REMARKS

The Office Action mailed July 16, 2002 has been carefully reviewed and considered. In response, a proposed drawing correction is provided, the specification has been amended and claims 1-2, 7, and 9-13 have been amended and new claims 17 and 18 have been added. Claims 1-2, 7, and 9-13 having been amended, and new claims 17 and 18 having been added, the claims now pending in the present application are claims 1-18. Favorable consideration is respectfully requested.

The drawings have been objected to for a variety of reasons set forth in the outstanding Office Action. A set of the original drawings is enclosed, including markings to indicate proposed changes to the drawings to address the objections raised by the Examiner. Also enclosed is a copy of the drawing pages as informally corrected. A discussion of specific objections raised by the Examiner with respect to the drawings follows below.

F16.4

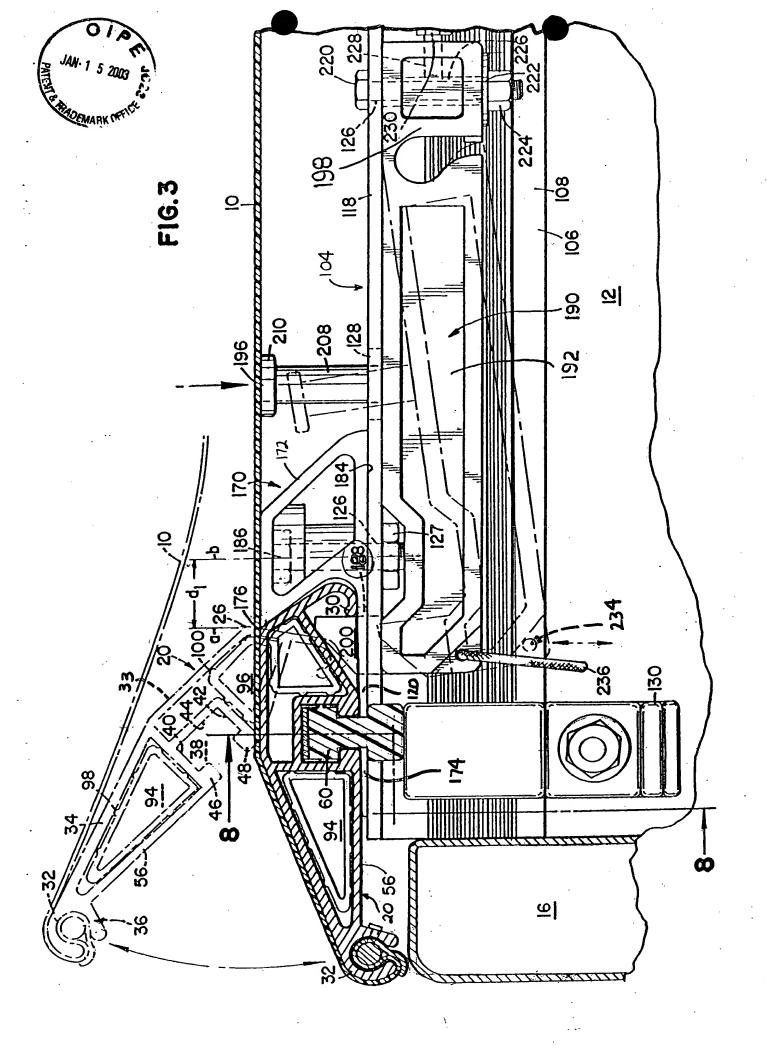
On page 3 of the outstanding Office Action, paragraph 4, the drawings are objected to because certain Reference Numbers are not mentioned in the description. In subparagraph a of paragraph 4, reference is made to Reference Number 22 in FIGS. 2 and 7. Reference Number 22 has been deleted in these FIGS. in the amended drawings.

FIG. 7

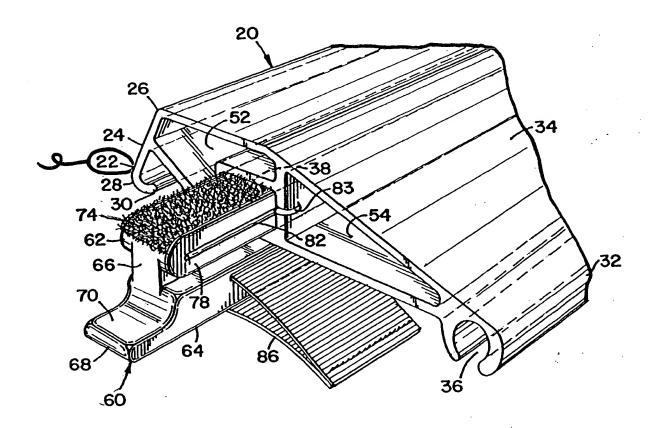
In subparagraph d of paragraph 4, the use of Reference Number 34 in FIG. 7 is objected to. In response, the specification has been amended at the end of the second full paragraph on page 11 which begins at line 21, to include a reference to a trailing surface 34 which is also referenced in FIG. 3.

FIG. 11

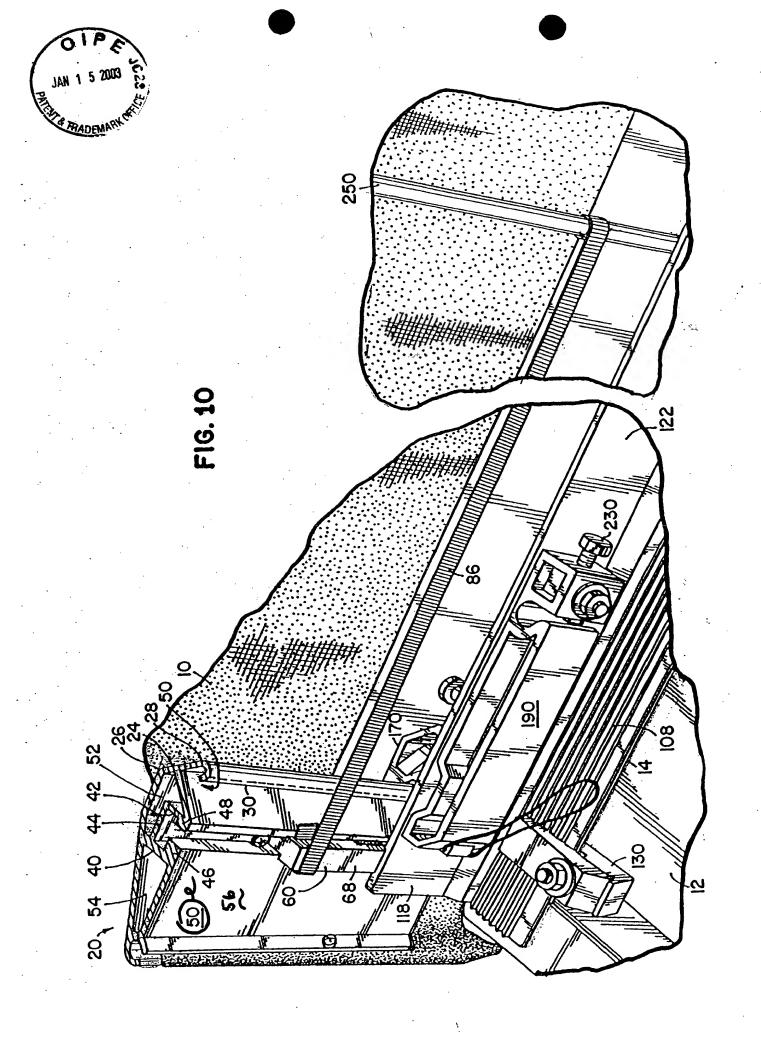
In subparagraph f of paragraph 4, it is noted that there is no reference to Reference Numbers 430 in the specification. The specification has been amended on page 20, in the paragraph which begins on line 23, to include a reference to a side panel 430 which is shown in FIG. 11, as well as to a flexible cover 410 which is also shown in FIG. 11.

FIG. 13

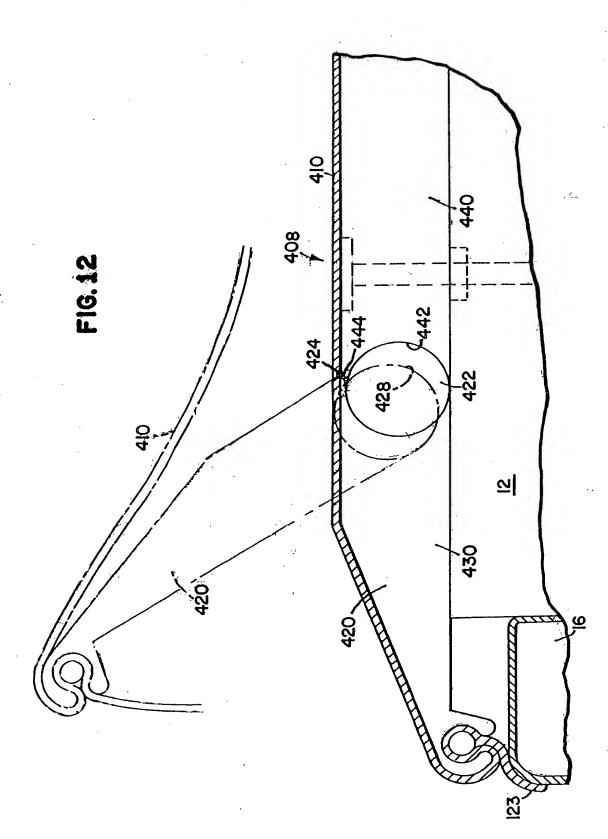
In subparagraph g of paragraph 4, it is noted that there is no reference to Reference Numbers 508, 536, 604, 630 and 664 in the specification; however, each of these Reference Numbers appear in FIGS. 13-15. In response, the specification has been amended to include references to each of these Reference Numbers. Support for the amendments to the specification is provided in FIGS. 1-10 which call out equivalent elements in the preferred embodiment disclosed in those FIGS. and also in the statement on page 22, lines 6-8 which, in reference to the alternate embodiment shown in FIGS. 13, 14 and 15, indicates that "The other features of this

In order to provide appropriate reference to these Reference Numbers, further description which finds support in FIGS. 13-15 and the aforementioned description of the preferred embodiment, has been added to the specification on page 22 at the end of the carryover paragraph.

F16.15

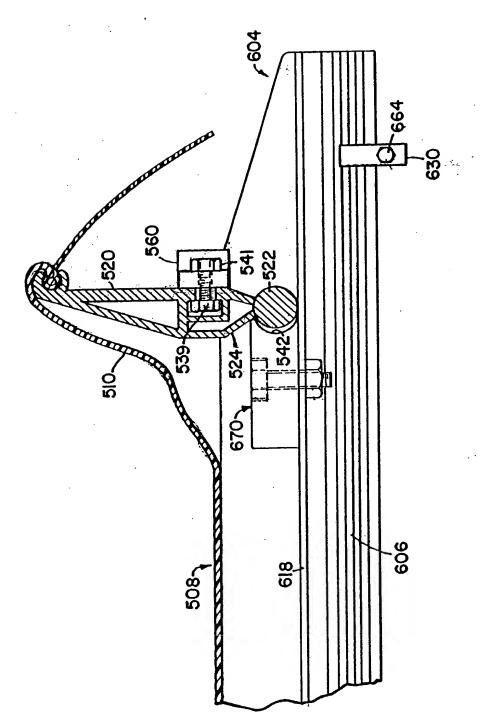
In paragraph 3 on page 2 of the outstanding Office Action, objections to the drawings are made because certain Reference Numbers do not appear in the various FIGS. in the drawings. In subparagraph a of paragraph 3, reference is made to Reference Numbers 120, 172 and 174 in FIG. 3. These Reference Numbers have been added to the amended drawings. In subparagraph b of paragraph 3, reference is made to Reference Numbers 122 and 130 in FIG. 8. These Reference Numbers have been added in the amended drawings. In subparagraph c of paragraph 3, reference is made to Reference Number 520 in FIG. 15. This Reference Number has also been added in the amended drawings.
